Amendments to the Drawings:

A complete set of replacement sheets for all the drawings is attached. The attached five replacements sheets, which include changes to FIGS. 4 and 5 and include newly-added FIG. 8, replace the original four sheets of drawings.

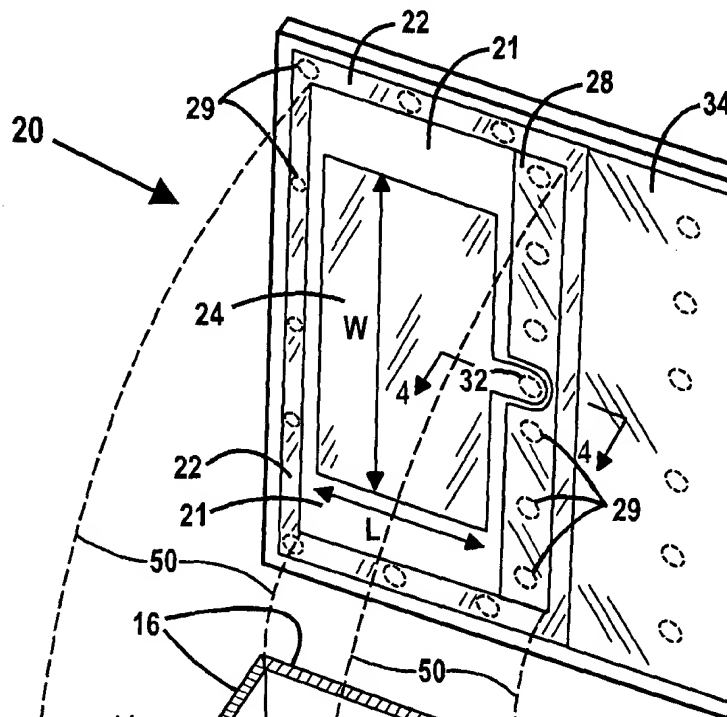
In FIG. 4, previously-omitted ground ring 22 has been added. The original FIG. 4 had show the combination of capacitive diaphragm 28 and ground ring 22 as a single element labeled by reference number 28. The changes to FIGS. 4 correspond FIG. 4 to the perspective view of original FIG. 1, and thus do not enter new matter. The relevant portion of FIG. 1, showing the cross-section plane for FIG. 4, is reproduced below:

The cross-section plane for FIG. 4 is defined in FIG. 2, as originally filed, and corresponds to that shown in the above portion of FIG. 1.
